**Response to NRC's Request for Additional Information  
by the Office of Nuclear Reactor Regulation for Topical Report  
WCAP-16608-P, "Westinghouse Containment Analysis Methodology"  
(TAC No. MD2953) (Non-Proprietary)**

REQUEST FOR ADDITIONAL INFORMATION  
RELATED TO WCAP 16608-P  
WESTINGHOUSE CONTAINMENT ANALYSIS METHODOLOGY

Figure A.3-3 Model 1 Short-Term RSLB Drywell Pressure Comparison

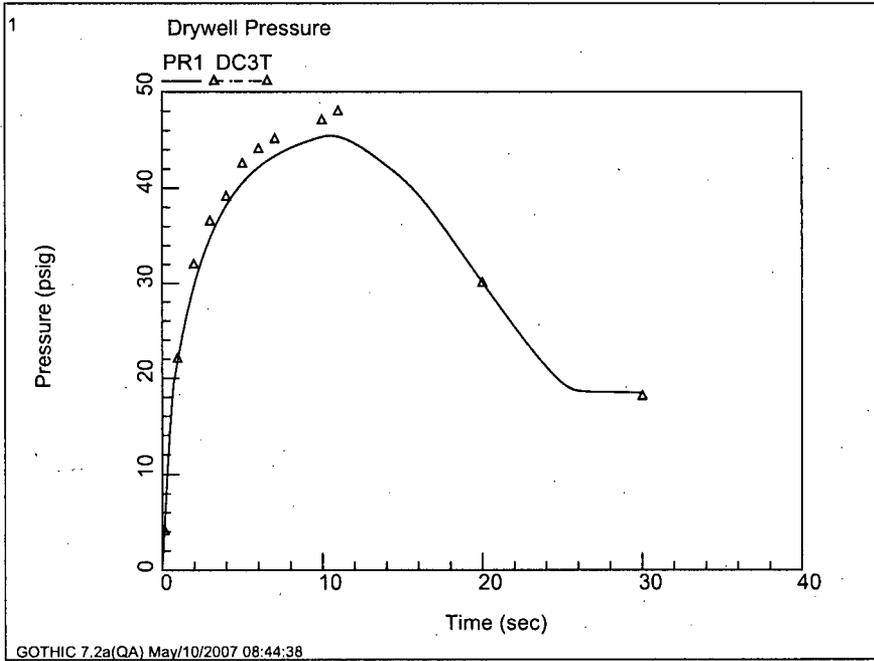
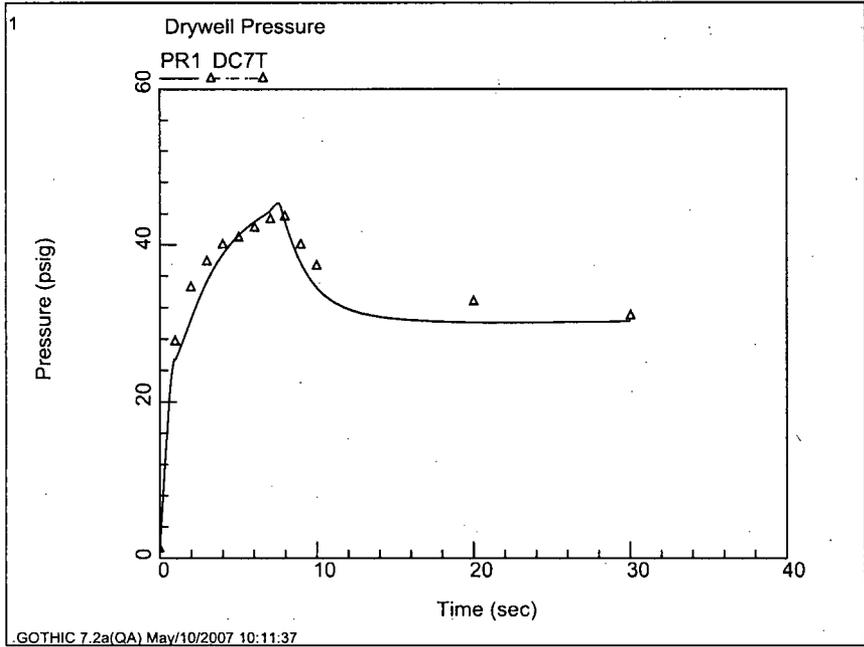
Figures A.3-3 and A.3-8 for Models 1 and 2, respectively, give peak drywell pressures of approximately 46 psig and 42 psig, respectively, while the peak drywell pressure for the Generic Model is approximately 44 psia or 29.3 psig - considerably less than either Model 1 or Model 2.

It therefore appears that when attempting to reproduce other BWR calculations, a high [ ]<sup>a,c</sup> is necessary. When using a [ ]<sup>a,c</sup> GOTHIC calculates a pressure much less than the other cases.

One explanation for this could be the modeling of droplets in the drywell and the downcomer flow. If a large fraction of the droplets are removed in the drywell, this would account for the need to [ ]<sup>a,c</sup> in Models 1 and 2 and also account for the low drywell pressure calculated by the Generic Model. This might also explain the lack of agreement with the wetwell pressure in Figure A.3-4.

It has been the NRC position that 100% entrainment should be assumed [ ]<sup>a,c,1</sup> This is consistent with comparisons with Humboldt Bay and Bodega Bay data.<sup>2</sup>

Please verify that GOTHIC is not removing droplets from the drywell atmosphere prior to flowing through the vents.

If removal of droplets is not the cause of the discrepancy between the [ ]<sup>a,c</sup> in Models 1 and 2 and the Generic Model, please explain why [ ]<sup>a,c</sup> are necessary.

The Model 1 and 2 RSLB short-term peak pressure benchmark comparison cases were re-run with the vent path modeling changes described above. The benchmark case vent path loss coefficient input values were not specified. After making the changes listed above, the vent path loss coefficient input value in Model 1 was reduced [ ]a,c and the vent path loss coefficient input value in Model 2 was reduced [ ]a,c to better match the benchmark. Tables A.3-1, A.3-2, and A.3-3 were revised to list these new loss coefficient input values and the revised short-term RSLB benchmark comparison figures for WCAP-16608 (Figures A.3-3 through A.3-11) are attached.

Figure A.4.2-4 RSLB minimum ECCS Backpressure Case Drywell Pressure Comparison

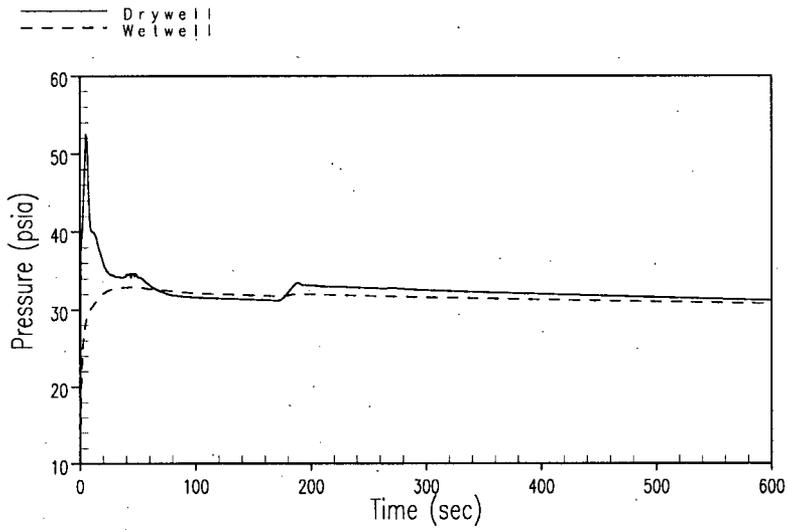
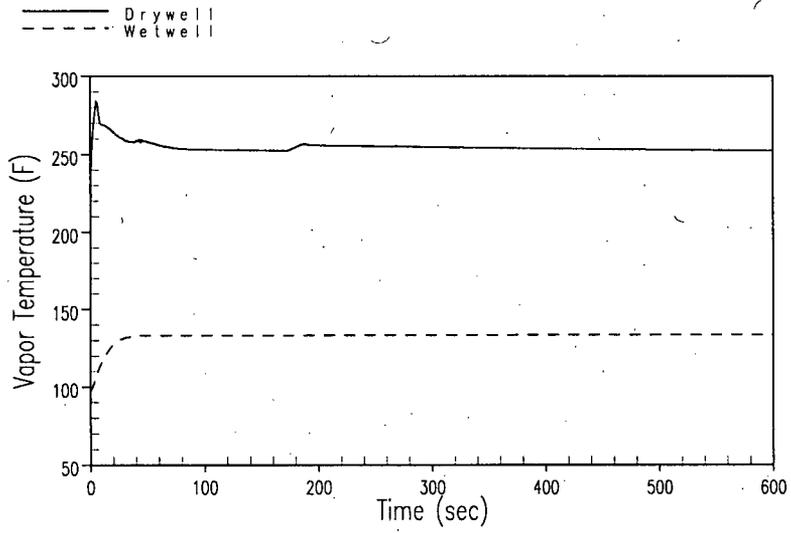
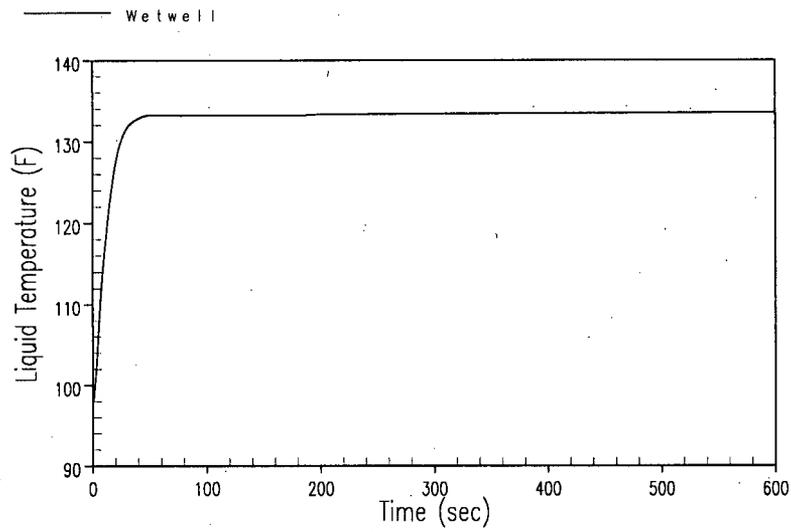
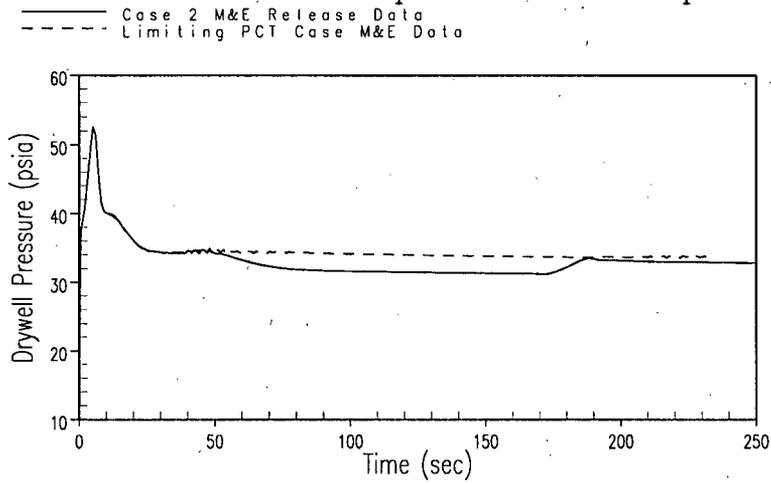
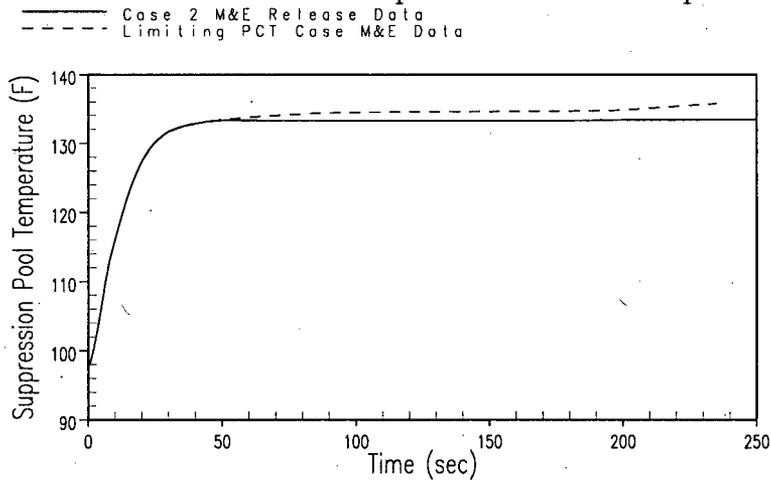
(b) Why couldn't other assumptions be included such as critical flow correlation less conservative than Moody, assuming 100% power rather than 102% power, a nominal decay heat, etc.

*The minimum ECCS backpressure input bias changes were made to the GOBLIN ECCS model to calculate new M&E release input for the GOTHIC minimum ECCS backpressure calculation. In addition, the GOTHIC minimum ECCS backpressure model was revised to address the vent path input changes described in RAI 13. As a result of these changes, Figures A.4.2-1 through A.4.2-5 from WCAP-16608 will be replaced with the figures shown in RAI 13.*

Figure A.4.3-1 RSLB Case 3 Pressure

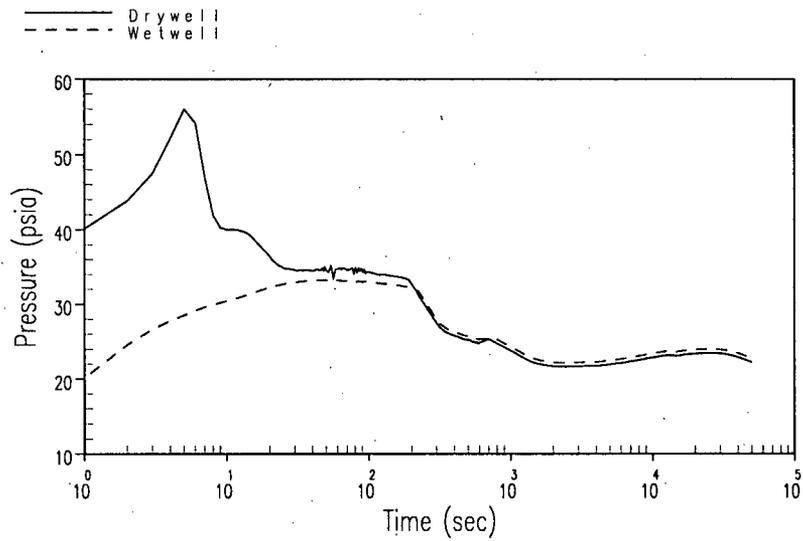
RAI 26. Section A.4.3 Figure A.4.3-1 Explain the initial decrease in drywell pressure during blowdown.

*Response: The initial pressure peak was due to inertia just prior to vent clearing, and the second peak was due to the vent path resistance. The inertia peak disappeared after the model input changes described in the response to RAI 13 were made. The revised figures for WCAP-16608 are attached – see RAI 13.*

Figure A.4.4-1 RSLB Case 4 Pressure

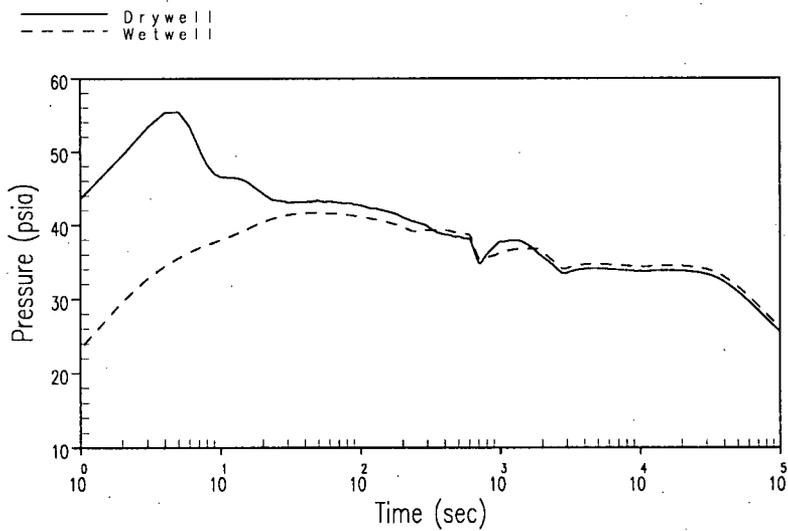
RAI 29. Appendix A Figure A.4.4-1 At times greater than  $2 \times 10^3$  seconds, the wetwell pressure appears to be slightly greater than the drywell pressure. Please explain.

*Response: The drywell gas pressure should be about the same as the wetwell gas pressure later in the event. The pressure, as calculated by GOTHIC, includes the head of water above the vertical center of the control volume. This explains why the wetwell pressure appears to be slightly higher than the drywell pressure.*
